MEMORANDUM

Re: Design Review Time Extension Request – 9th East Mixed-Use and Multifamily

RE: PLNPCM2020-00641 – 9th East Mixed Use and Multifamily

ATTACHMENT C: REVISED SUBMITTAL

1 MAIN LEVEL SETBACKS

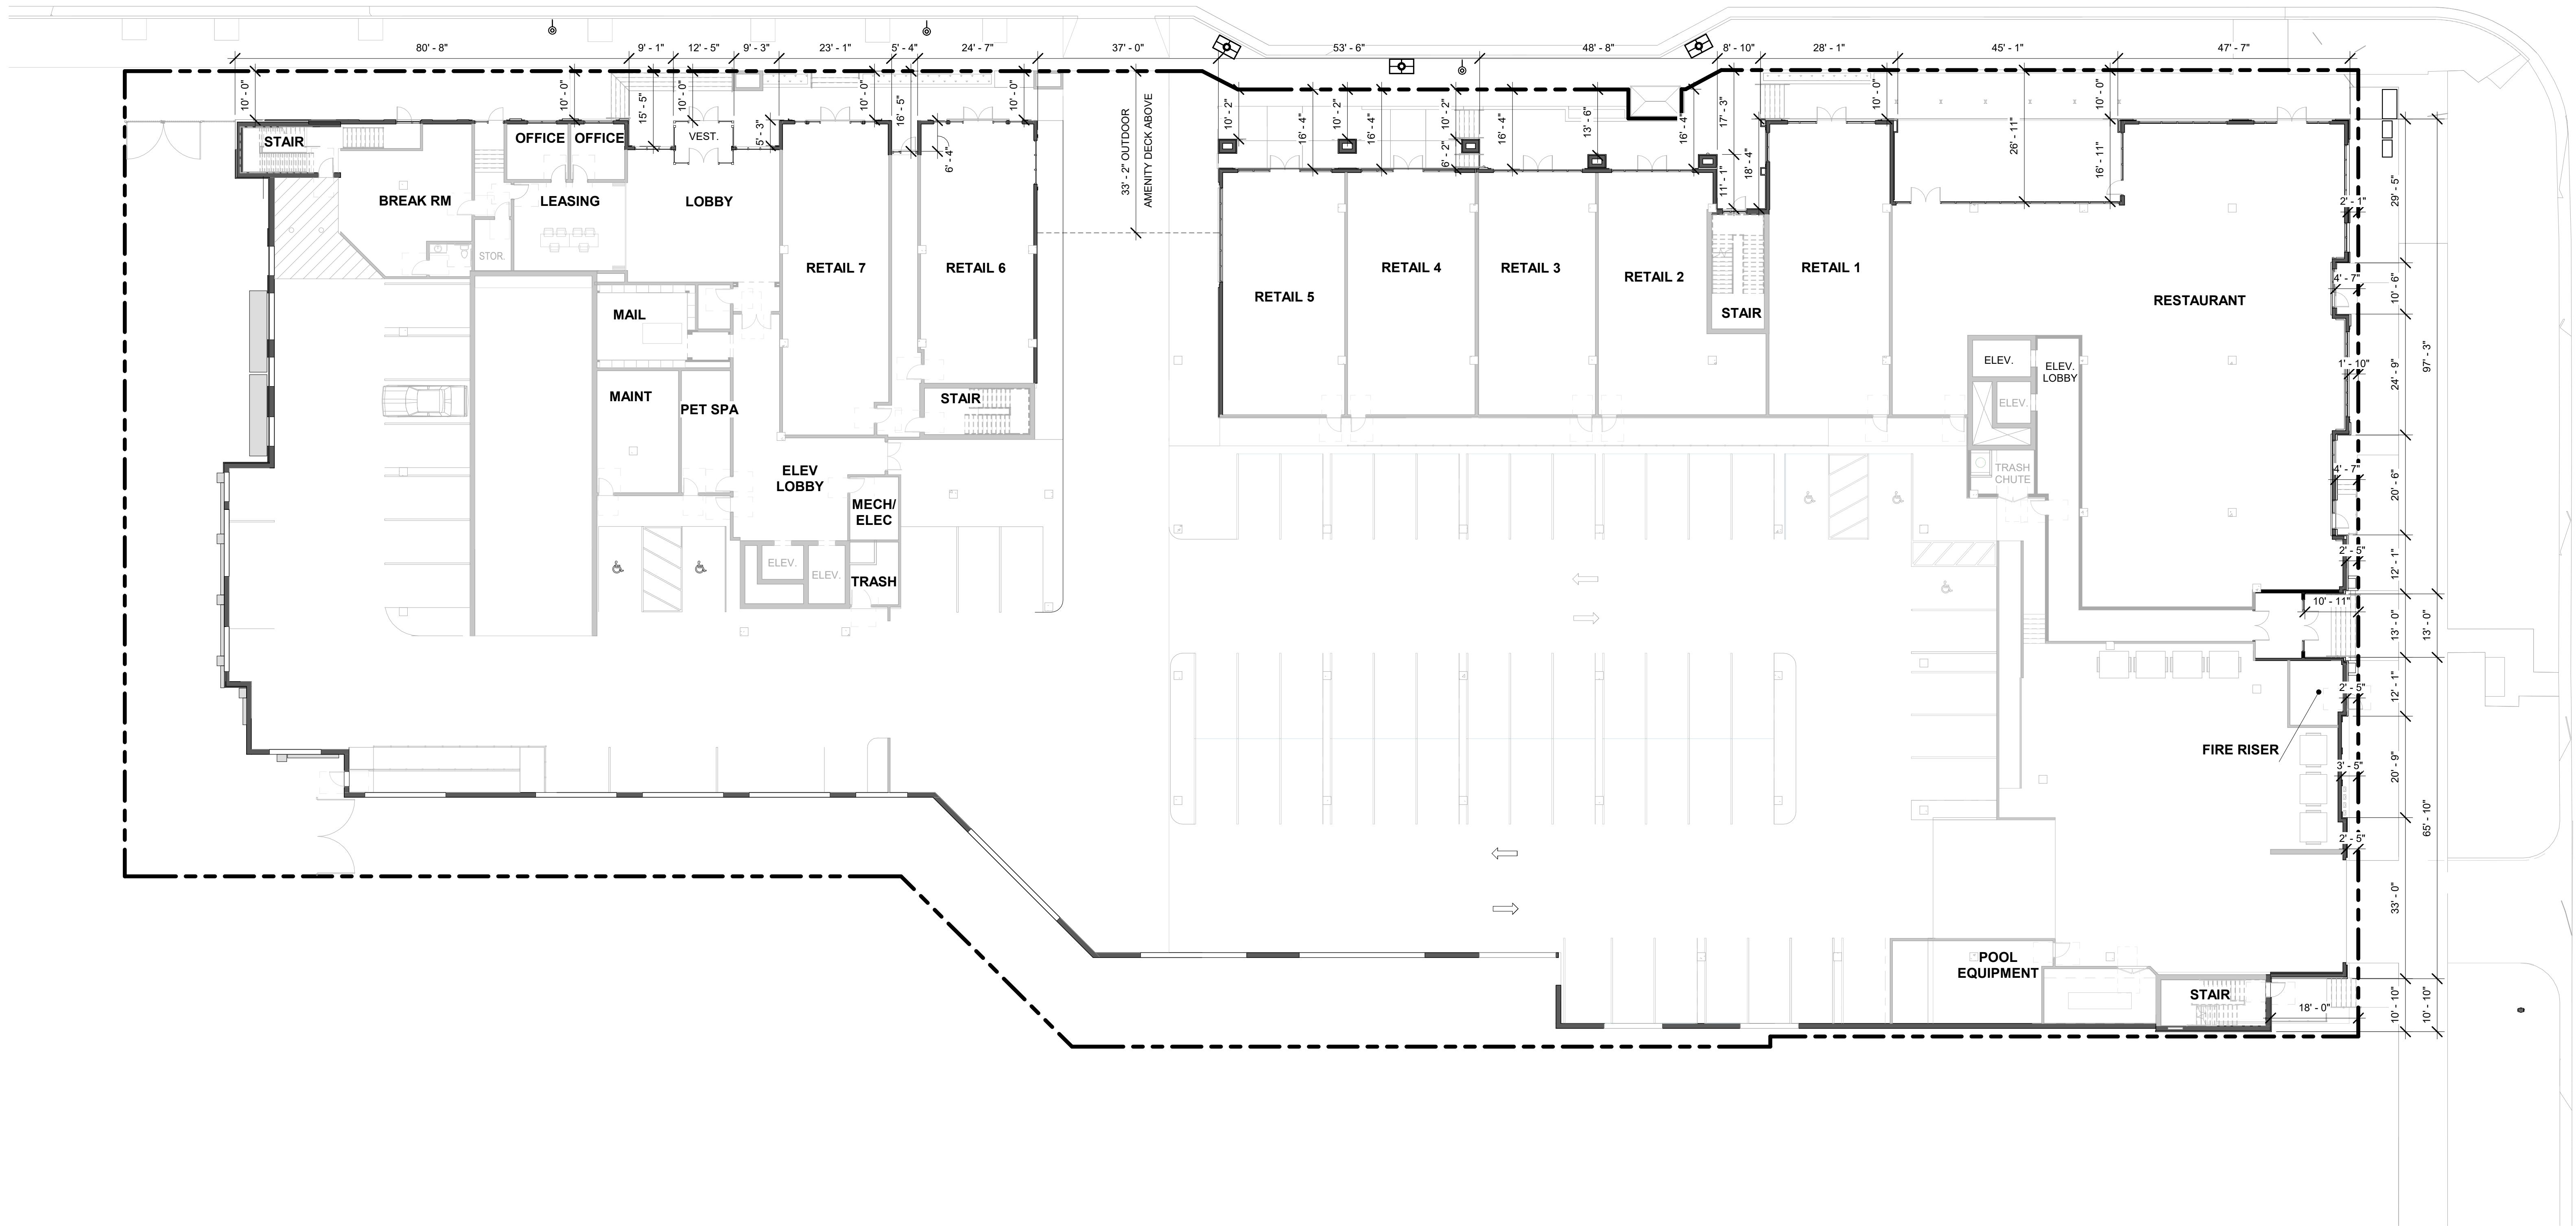
- Generally, consider increasing articulation to provide the appearance of increased separation between sections of the building. (21A.59.050.D.2 and E.1).

Response: We have increased the setback of the second floor amenity deck/parking entrance from the front façade, see sheet A102.
